PHILADELPHIA ELECTRIC COMPANY

Docket No.: 50-353

Subject: Limerick Generating Station, Unit 2
Charcoal Filter Cooldown Mode for
Reactor Enclosure Recirculation System

RERS COOLDOWN FLOW PATH NO. 1

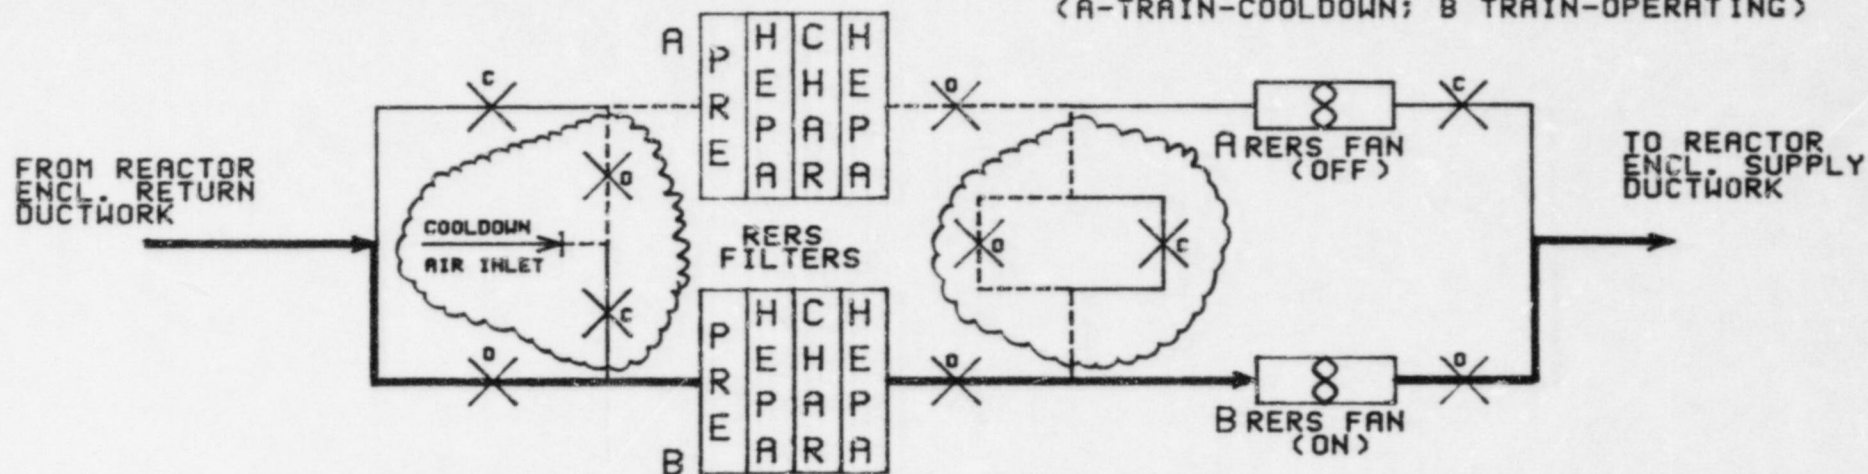
Based on the foregoing, we propose to eliminate the charcoal adsorber cooldown mode from RERS for Limerick Unit 2.

COOLDOWN FLOW PATH THRU STANDBY
FILTER WITH LEAD FILTER IN OPERATION
(A-TRAIN-COOLDOWN; B TRAIN-OPERATING)

— RERS MAIN FLOW
 - - - COOLDOWN PATH
 — NO FLOW
 (cloud) PROPOSED DELETION

RERS COOLDOWN FLOW PATH NO. 2

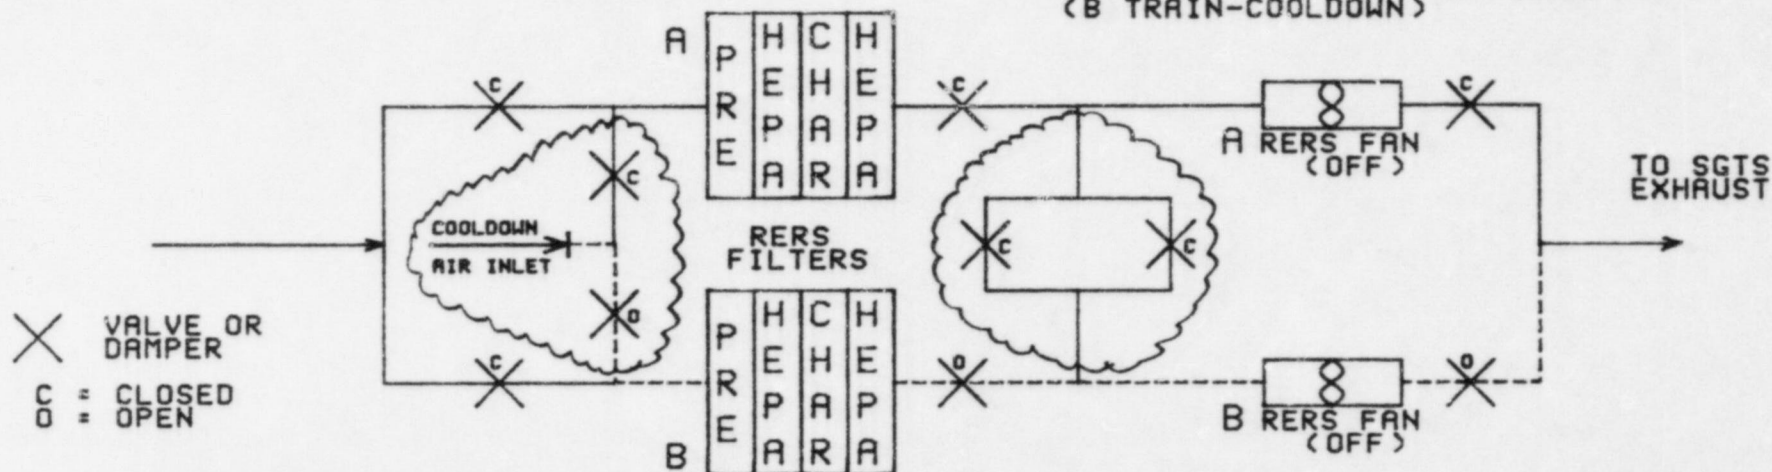
COOLDOWN FLOW PATH THRU FILTER
WITH NEITHER RERS IN OPERATION
(B TRAIN-COOLDOWN)
